Work Order ID 52147

Item Name: Skidtube RH

DART SERVICE INSTRUCTION

TO AMEND INSTALLATION INSTRUCTIONS IIN-D209-669 REV. B

5.0 PARTS LIST

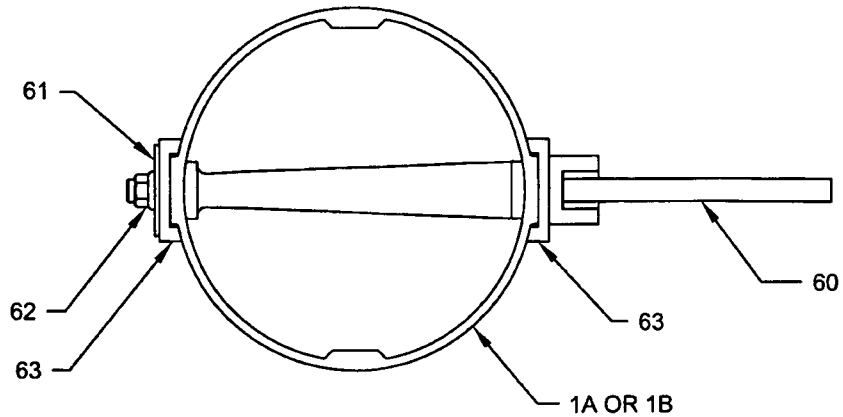
- a) REPLACE THE D2968-041 TOW RING WITH THE D3407-041 TOW RING ASSEMBLY.
- b) REPLACE THE D2736-1 AND D2736-3 GHW LUGS WITH THE D3405-041 AND D3405-043 LUG ASSEMBLIES.
- c) AMEND THE PARTS LIST IN SECTION 5.0 OF INSTALLATION INSTRUCTIONS IIN-D209-669 REV. B AS SHOWN ON PAGE 2 OF THIS DSI.

NOTE: ALL INSTALLATION FASTENERS FOR THE ABOVE CHANGES HAVE BEEN UPDATED. SEE THE AMENDED PARTS LIST ON PAGE 2 FOR DETAILS.

50	4	4	1	1			D3405-041	LUG ASSEMBLY
51	8	8	4	4			AN4C47A	BOLT
52	16	16	8	8			D2570	BUSHING
53	8	8	4	4			MS21043-4	NUT
54			1	1			D3405-043	LUG ASSEMBLY
60	1	1	1	1			D3407-041	TOW RING ASSEMBLY
61	1	1	1	1			D3456-1	WASHER
62	1	1	1	1			MS21043-4	NUT
63	2	2	2	2			D3417-5	WASHER

50	4	4	1	1			D2736-1	GHW LUG
51	8	8	4	4			AN4-46A	BOLT
52	16	16	8	8			D2570	BUSHING
53	8	8	4	4			MS21042L4	NUT (OR MS21042-4)
54			1	1			D2736-3	GHW LUG
60	1	1	1	1			D2968-041	TOW RING
61	1	1	1	1			AN970-4	WASHER
62	1	1	1	1			MS21042L4	NUT (OR MS21042-4)
